## CITY OF RIALTO CONTRACT CHANGE ORDER

Date: 03/10/2020  
Project No: 170808  
Project: Metrolink Parking Lot Expansion  
Project Phase 2

Change Order No: 01  
Purchase Order No: 2019-1288  
Account Number(s): 223-500-4408-3001-170808-05

**CITY OF RIALTO**  
METROLINK PARKING LOT EXPANSION - PHASE 2  
GRADING & DRAINAGE PLAN - SHEET 1

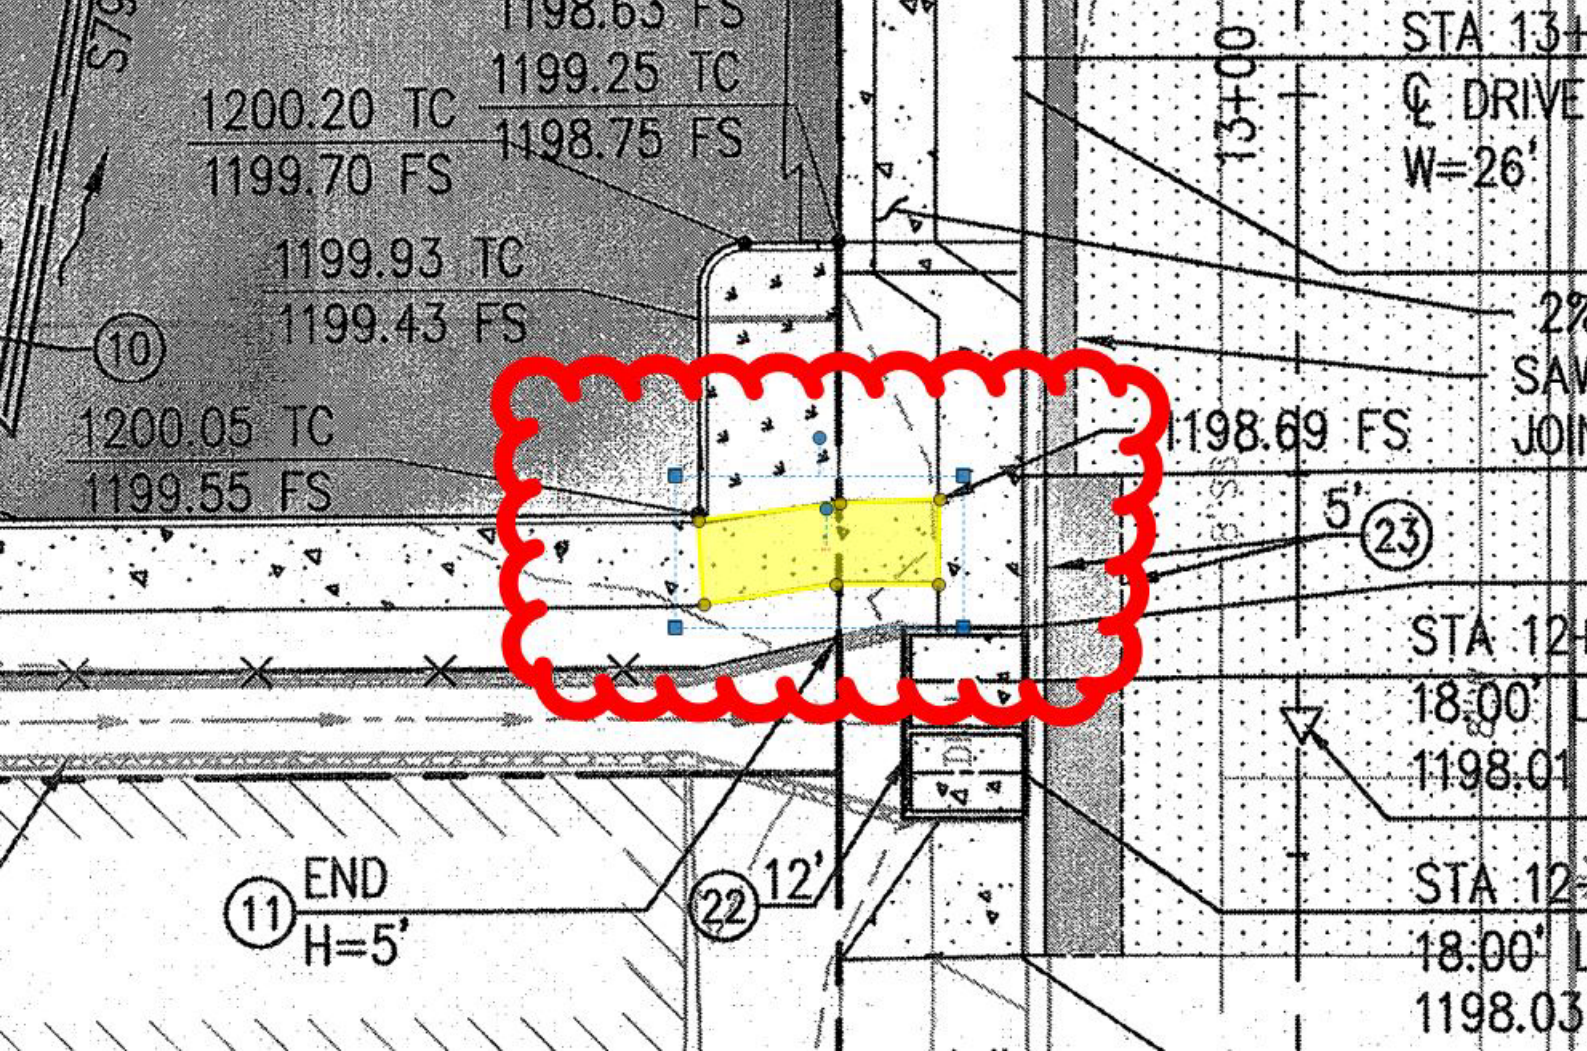
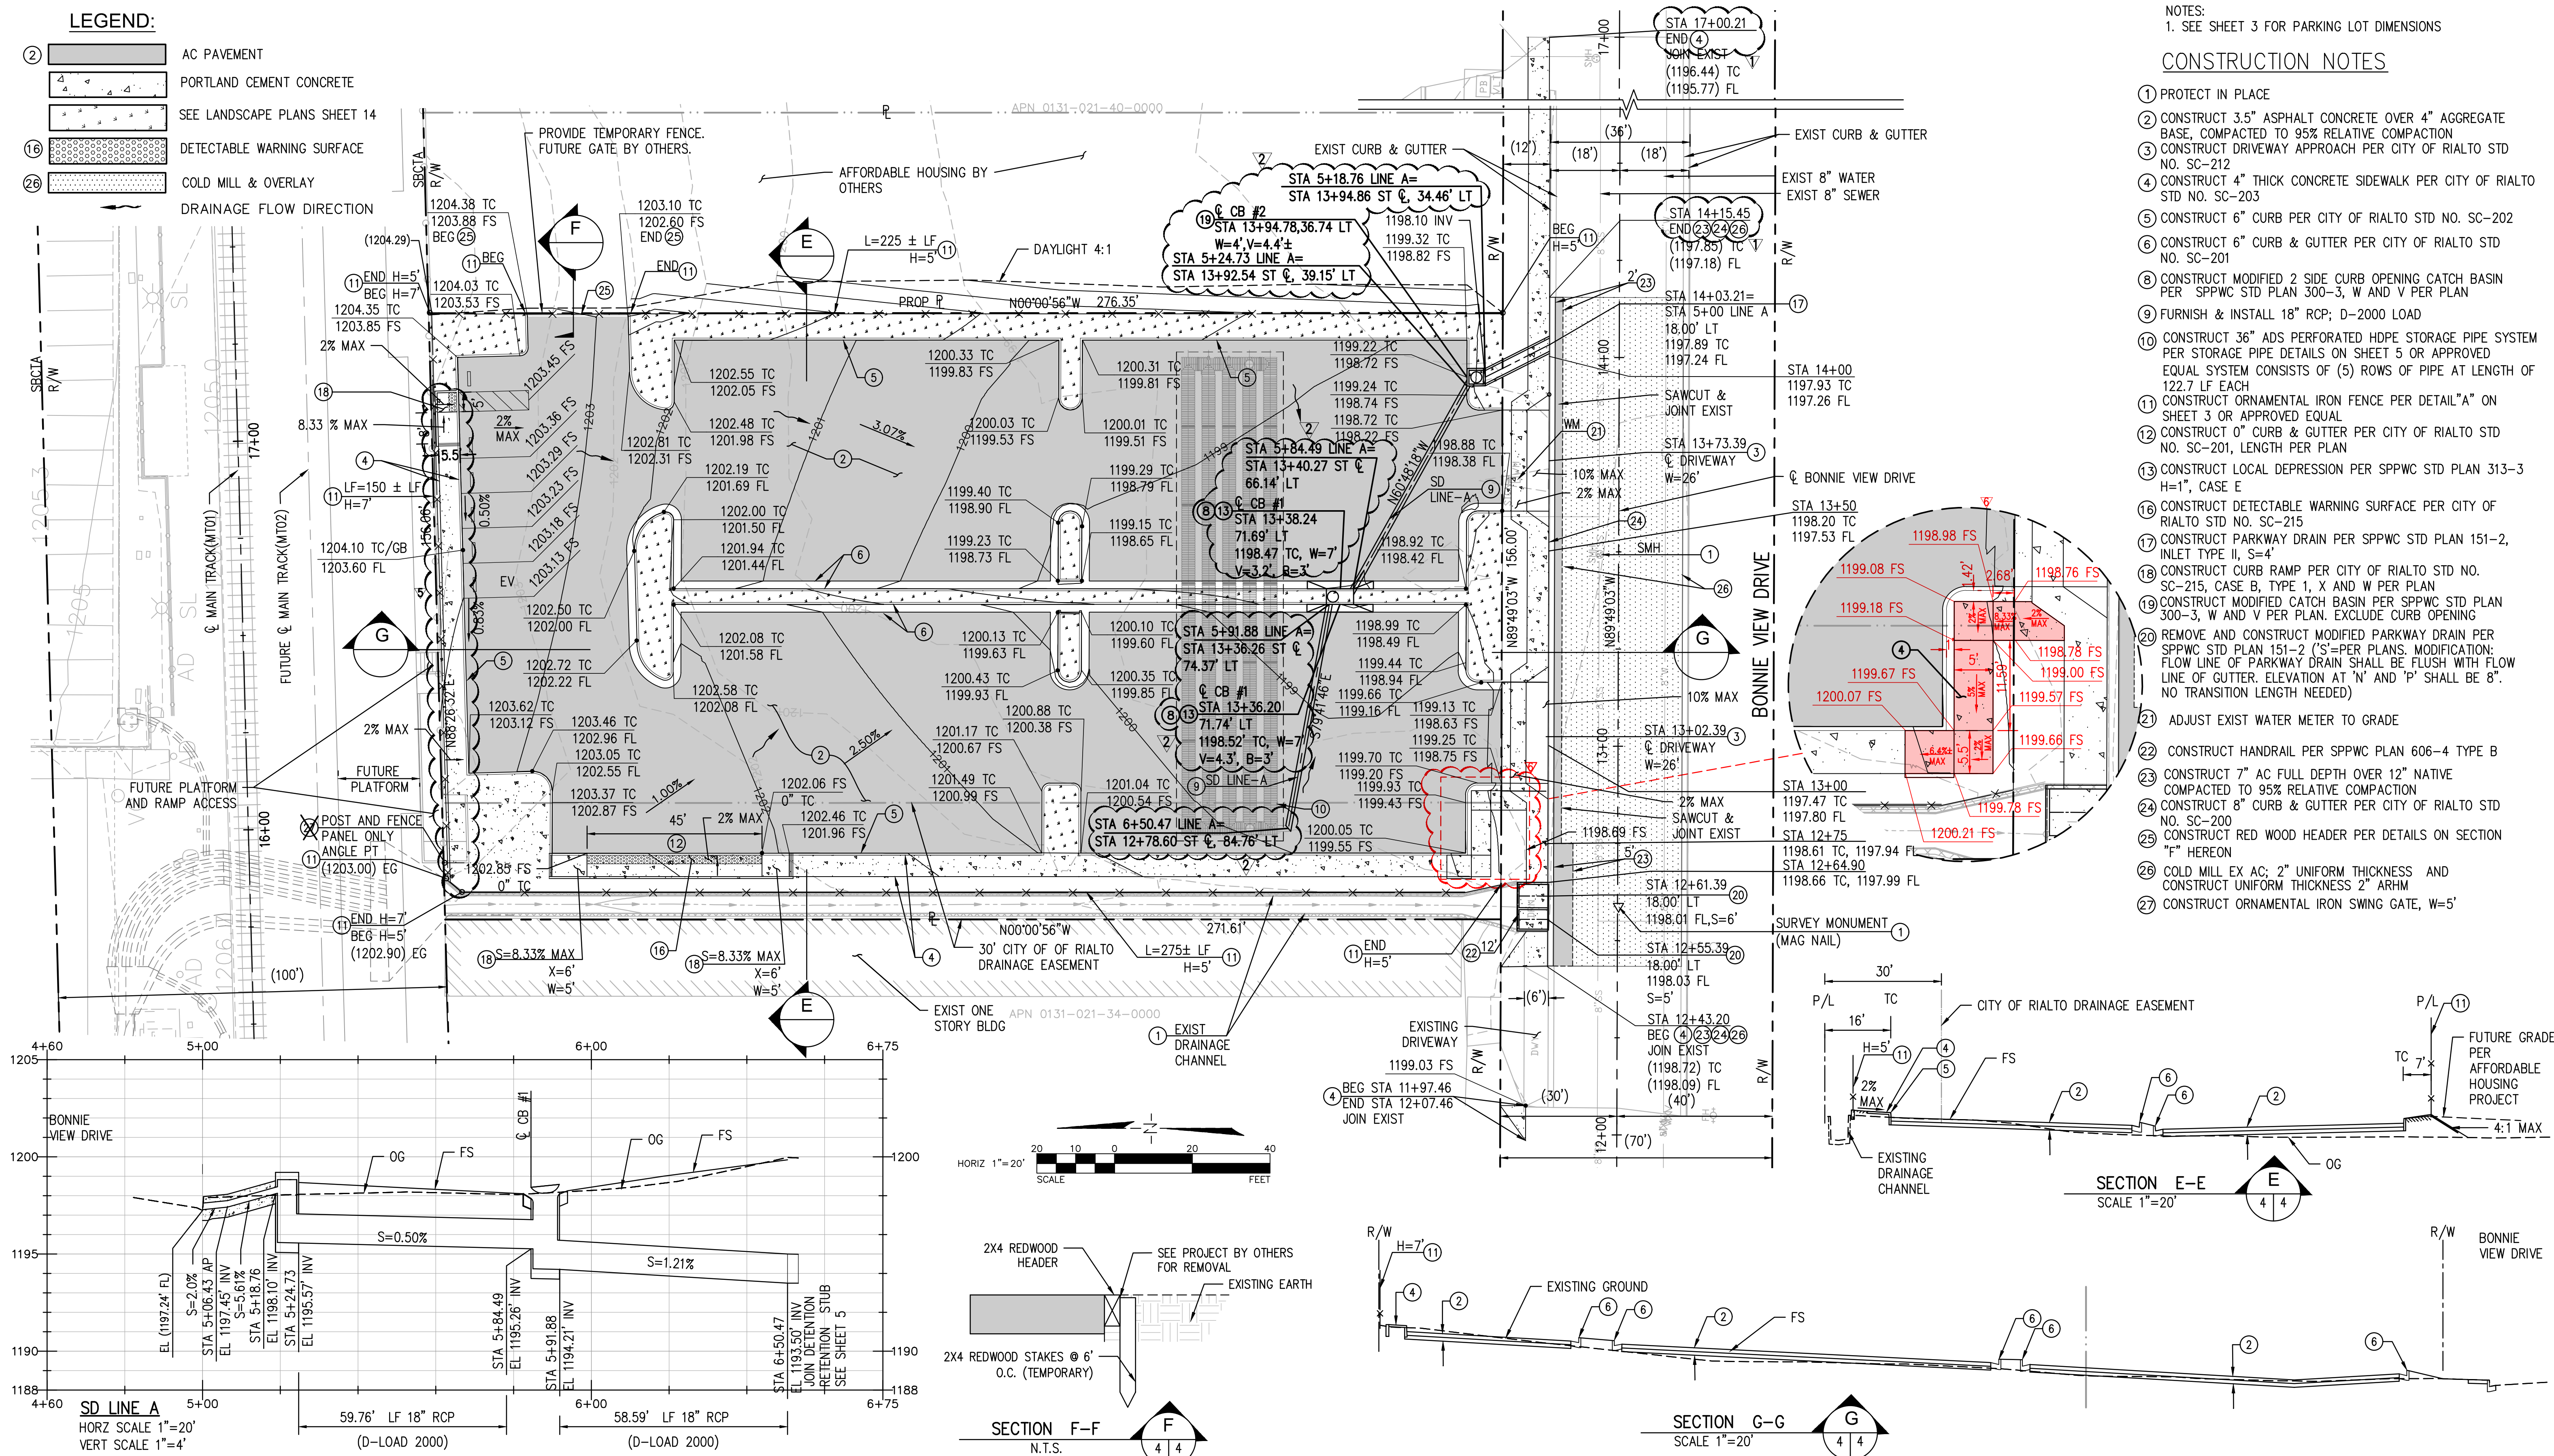
Please see attached sketch from sheet 4. The slope of the sidewalk is over 8% in the highlighted area. If this is a ADA path of travel, the slope would be too steep. Please confirm if we are ok to pour concrete sidewalk per plan.
